COUNCIL ASSESSMENT PANEL MEETING

AGENDA – 9.2

Applicant: Lloyd Building Solutions Pty Ltd	Landowner: B S Lloyd & J Bala
Agent: N/A	Originating Officer: Ashleigh Gade
Development Application:	20/1049/473
Application Description: Single storey split level detached dwelling, deck (maximum height 2.6m), retaining walls (maximum height 1m), domestic outbuilding - garage & associated earthworks	
Subject Land: Lot:391 Sec: P81 DP:123071 CT:6234/308	General Location: 34 Fern Hill Road Bridgewater Attachment – Locality Plan
Development Plan Consolidated : 8 August 2019 Map AdHi/31 & 75	Zone/Policy Area: Country Living Zone - Country Living (Bridgewater) Policy Area
Form of Development: Merit	Site Area: 964m ²
Public Notice Category: Category 2 Merit	Representations Received: 2 Representations to be Heard: 2

SITE PLAN

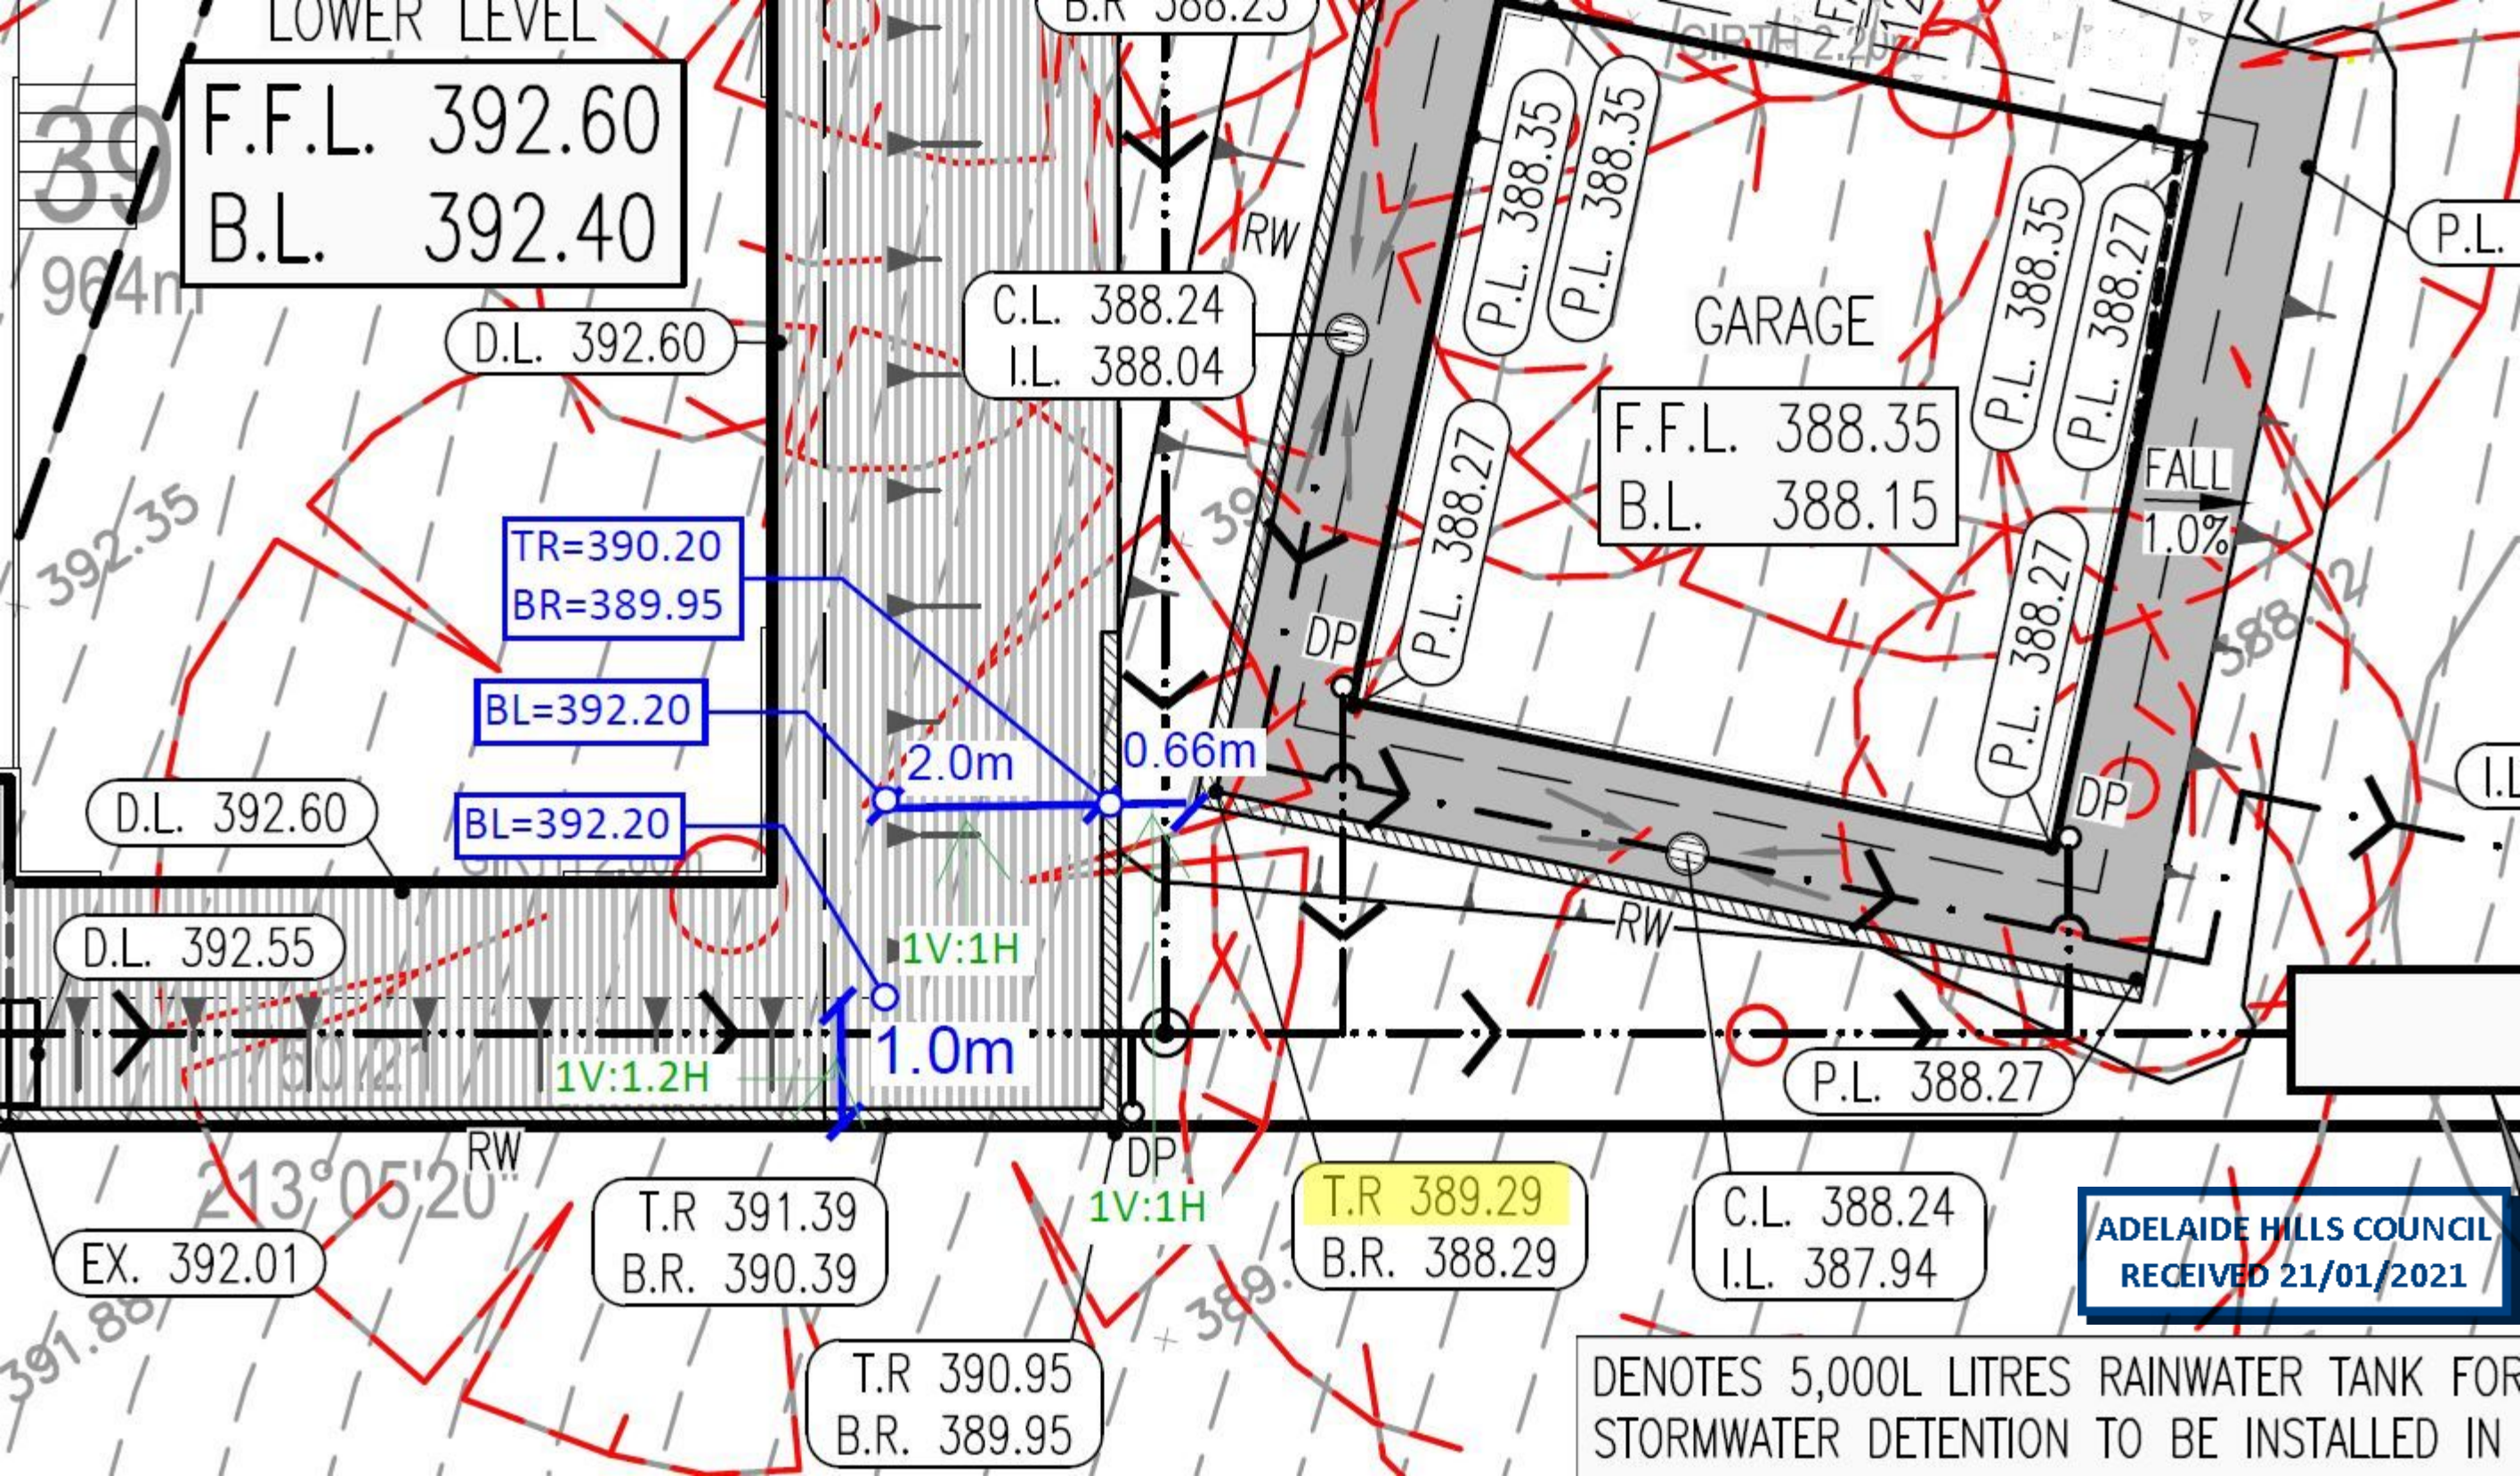
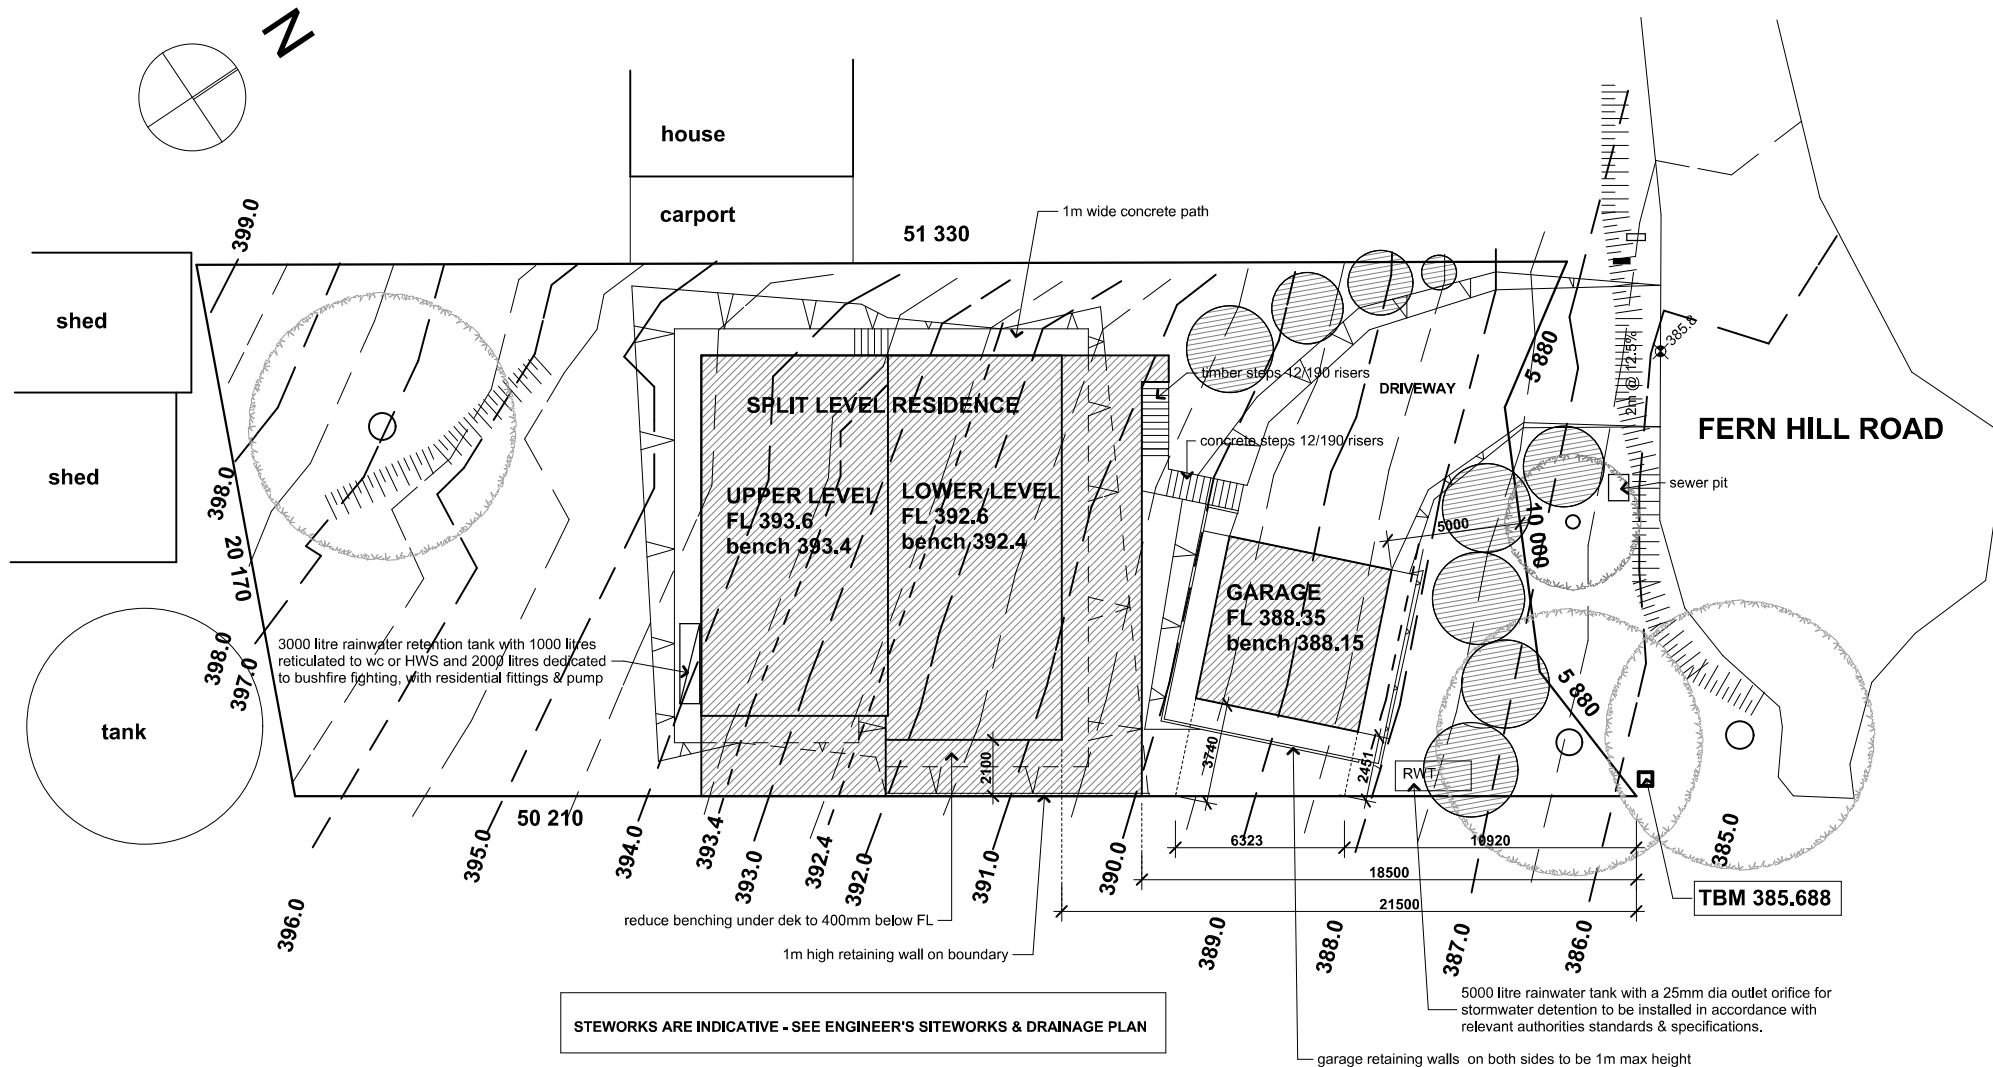
Additionally, as discussed, it is requested that all retaining wall heights be specified on the Siteworks Plan and be consistent with those quoted on the Site Plan.

I will have an amended site plan soon, which I will forward to you with additional landscaping details to the front of this property as requested. It has taken a bit longer than anticipated hence the reason I thought I would get the rest of the above to you now and follow up with that as soon as possible.

5A NORTH WEST ELEVATION
1:100

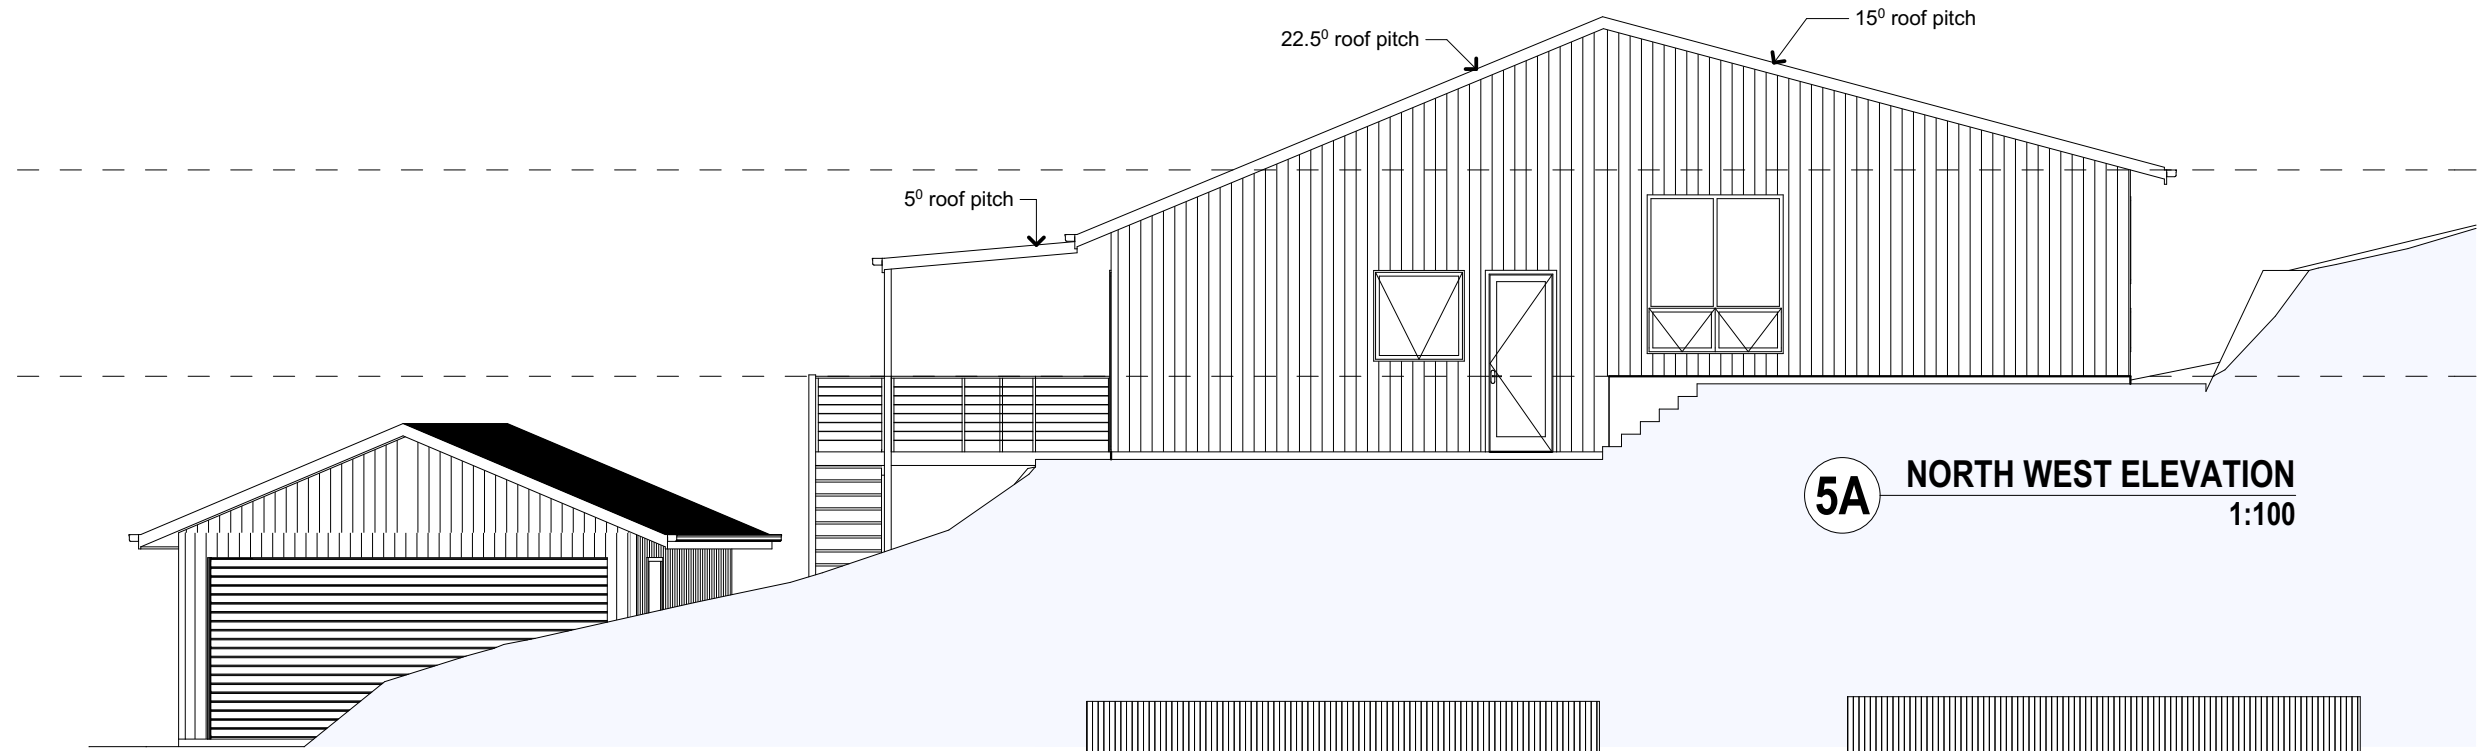
We have attempted to get a bearing on the height of the house as per picture 5A in plans. This is the side of the house that will be in our line of vision from our front verandah, carport and upstairs living area. I can see that there is an approximately two-metre deep cutting from the height of our driveway, but we request to clearly see in the plans where the highest point of this side roof is, in relation to our carport/house. Could a Street Scape Elevation plan be provided so that this can be viewed, as we are concerned that the home could significantly impact our views from our verandah and upstairs living area. This could also result in lack of privacy for both us and the new residents, as there are two windows (including a bedroom) and a glass door on the western side of the proposed dwelling.

Could be resolved by - a street scape elevation plan that may alleviate our concerns, and/or assured provision for adequate screening, either natural and/or otherwise.
